Product Change Notification

Date Issued :	March 22, 2022	PCN Number :	511774
Reason for Change :	Packaging Method/Quantity Changing		
Description of Change :	This notification is to inform you that the part(s) listed in this notice that will undergo changes for a new Delivery unit. No changes will be made to the product as a result of this change.		
Reason for Short Notice :	Corrective Actions		
Assessment of Change :	Dimension analysis		
Planned Implementation Date :	May 06, 2022		
Sample Availability Date:	May 06, 2022		
Internal Molex Qualification Date :	April 15, 2022		
Last date to request Samples by Customer :	March 22, 2022

Before Picture

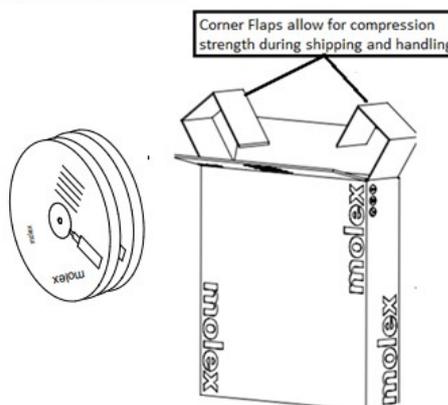
Change Point

Before:

Single Reel 2,500 pcs
Box 309076500

- Current Packaging is 1 reel (2500pcs) in Box 309076500
 - Box Dimensions are 30 x 30 x 2.25"
 - Small minor flaps at corners do not allow for compression strength when box is closed allowing corners to crush and potential for reels/product in box to be damaged during shipping and handling.

After:

2 Reels 5,000 pcs
Box 85-01-0030

- New Packaging will be 2 reels (5000pcs) in Box 85-01-0030
 - Box Dimensions are 30.25 x 30.25 x 4.06"
 - Corners have minor flaps that tuck well and provide the outer corners with additional compression strength during shipping and handling (as shown on slide 1 after photo)
